Access Compliance Report

Public Rights-of-Way

(Curb Ramps)

Intersection ID: 47469	Main Street: KALISPELL_LN	Cross Street: ELENDIL_LN	Location: SE
ADA ID: C59BA9E9EC9A	Ramp Type: BlendTrans1	Initial Pass/Fail: Fail	Overall Compliance: No
Severity Score: 8.75			
Codes/Mitigation Info/Possible Solution		Field Measurements/Component Compliance

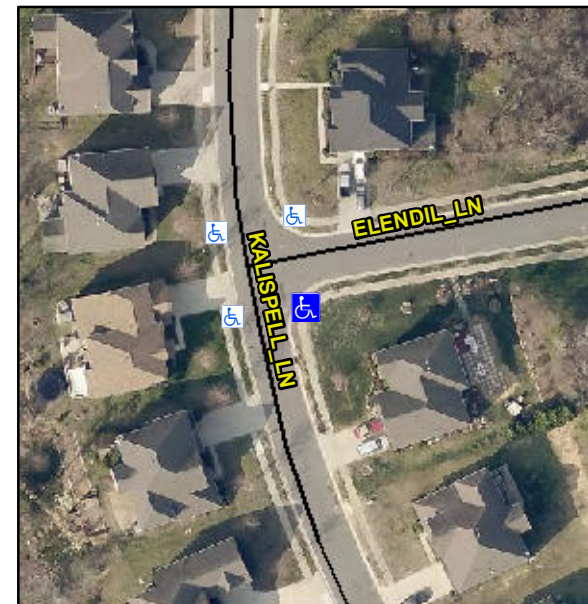
Not Found, R304.5.1

Compliance	Description	Data	Compliance	Description	Data
N/A	Ramp Length (in)	48.0	Yes	BlendTrans Slope (%)	1.5
No	Ramp Width (in)	47.0	Yes	BlendTrans XSlope (%)	0.8
N/A	Flare Type LT	N/A	N/A	Flare Type RT	N/A
N/A	Flare Slope LT (%)	N/A	N/A	Flare Slope RT (%)	N/A
N/A	Flare Traversable LT?	N/A	N/A	Flare Traversable RT?	N/A
N/A	Landing Length (in)	N/A	N/A	DWS Provided?	N/A
N/A	Landing Width (in)	N/A	N/A	DWS Contrast?	N/A
N/A	Landing Slope (%)	N/A	N/A	DWS Length (in)	N/A
N/A	Landing X Slope (%)	N/A	N/A	DWS Full Width?	N/A
N/A	Landing Curb? (Y/N)	N/A	N/A	DWS Offset (in)	N/A
N/A	Shared Landing?	N/A			
N/A	Gutter Ponding?	N/A	N/A	Gutter Slope (%)	N/A
N/A	Gutter Lip Ht (in)	N/A	N/A	Gutter X Slope (%)	N/A
N/A	Painted X Walk1?	No	N/A	Painted X Walk2?	No
	X Walk 1 Direction	To N		X Walk 2 Direction	To W
	X Walk 1 Width (in)	N/A		X Walk 2 Width (in)	N/A
	X Walk 1 Slope (%)	0.1		X Walk 2 Slope (%)	1.0
	X Walk 1 X Slope (%)	0.0		X Walk 2 X Slope (%)	2.2

N/A	Ramp inside XWalk1?	N/A	N/A	Ramp inside XWalk2?	N/A
	Road Slope (%)	1.5		Clear Space?	N/A
	Road X Slope (%)	2.2	N/A	Clear Space to XWalk (in)	N/A
N/A	Any Obstructions?	N/A	N/A	Storm Grate/Utility Hazard?	N/A
	Obstruction Type			Storm Grate/Utility Type	
		N/A			N/A
			Yes	Surface Condition? (G/P)	Good
			No	Curb Slope (%)	7.7

Remove & Replace Curb Ramp With Two New Directional Ramps or Equivalent.
